KOITO MANUFACTURING CO., LTD.

Re: Docket No. NHTSA-2022-0013; Fed. Reg. Vol. 87, No.35, February 22, 2022

Figure 2. Iso-lux curve of lower beam on 15 m screen
(Right curve with 210 m radius)

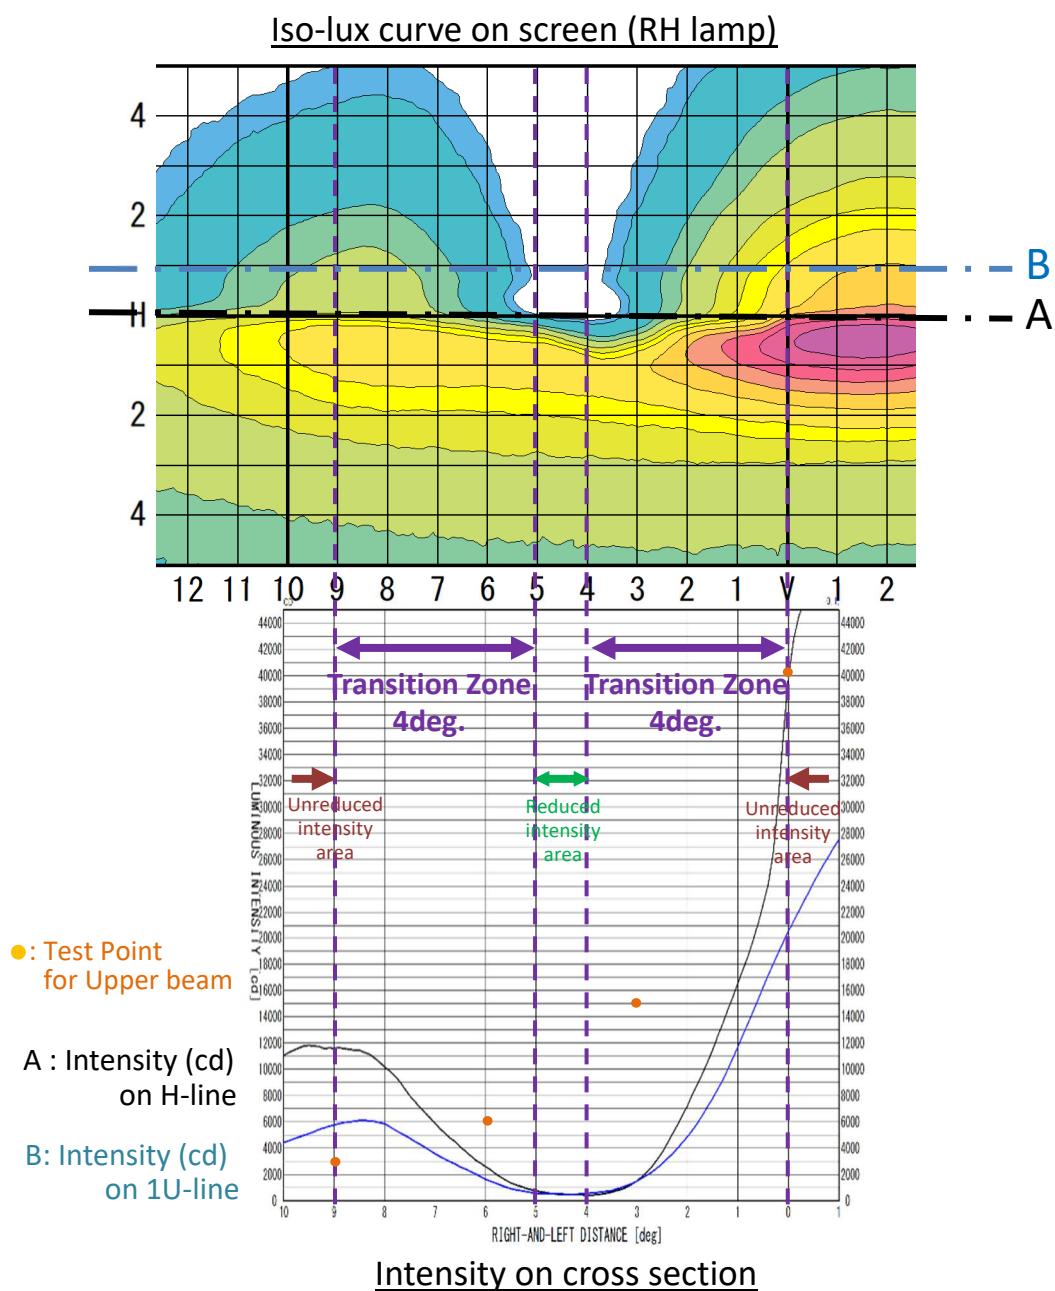
The ADB final rule seems to unintentionally make severer glare requirement to the current low-beam headlamp. The maximum glare value of ADB is required in Table XXI of FMVSS 108, and the photometer for evaluating glare is located 1.1m above the ground. On the other hand, the current low-beam is required 500 cd minimum and 2,700 cd maximum at 0.5U 1Rto3R. When performing the right curve testing scenario with rather higher mounted headlamp, there is a possibility that a low-beam with ADB turned off does not comply with the requirement in Table XXI. (For example, this kind of possibility with Koito's ADB is shown in the attached Figure-2.) In order to resolve this inconsistency, we are considering following solution;

There is a possibility that a low-beam alone (with ADB turned off) does not comply with the ADB glare requirement in Table XXI.

Add "ADB cannot exceed by more than 25% the intensity levels the ADB vehicle's lower beam.", as an alternative of ADB glare requirement of Table XXI.

This solution is also based on the idea of SAE J3069 (Section 6.5.1.2). As an alternative requirement for Table XXI, we believe it is reasonable solution because there is no affect to the headlamp mounting height.

Figure 1. Iso-lux curve of ADB

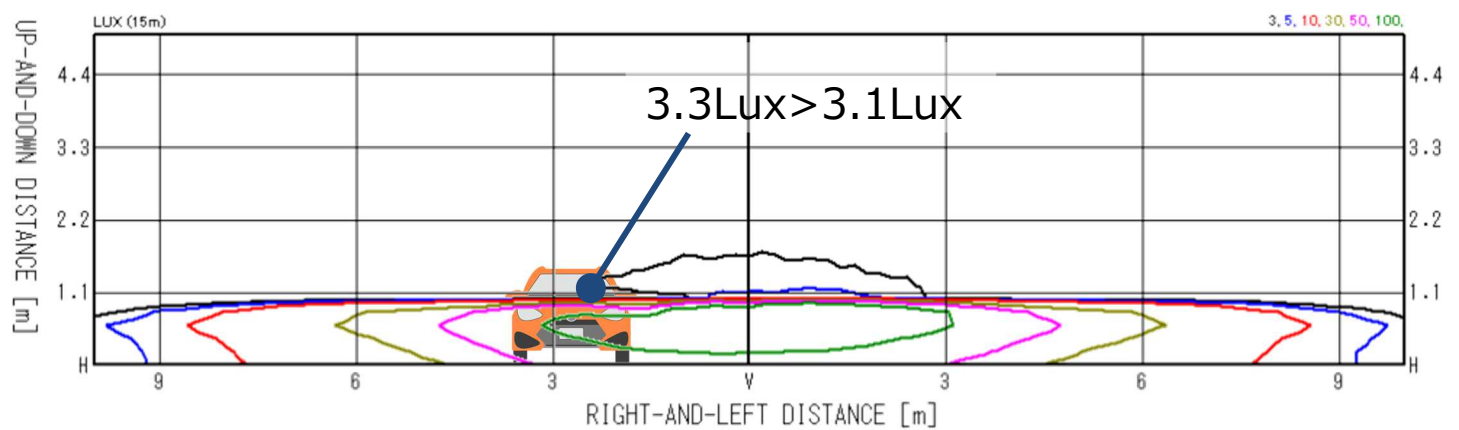
The most popular ADB today has an optical system with shifting and overlapping segments of light, which is cost-effective and provide better visibility by smooth transition between reduced and unreduced intensity areas. However, this system does not comply with the ADB photometric requirement due to 1-degree transition zone. ADB final rule requires the unreduced intensity area to reach full upper beam level within 1-degree transition zone. But the safety benefit for requiring 1-degree transition zone is not identified.

Although most of Koito's ADB systems has transition zone of approx. 4 degrees, they can improve visibility and contribute to safety in Japanese and European markets. (For example, iso-lux curve of Koito's ADB is shown in the attached Figure-1.) High-resolution ADB could comply with the ADB requirement, but it is expensive and very small number of such ADB system is in the market.

This ADB needs 4-degree Transition Zone for complying with the photometric requirement of the unreduced intensity area (40,000 cd min. at HV).

Delete the transition zone, and change ADB photometric requirements to meet the minimum and maximum lower-beam values in reduced-intensity area, and to meet minimum lower-beam values and maximum upper-beam values in the unreduced-intensity area.

This solution is based on the idea of SAE J3069, and SAE submitted similar comment when NPRM was issued in 2018. Although ADB final rule explained NHTSA's reluctance to adopt it, it is practical and reasonable solution, so Koito would like to continue support ADB. And this solution means that the Transition Zone is no longer needed.
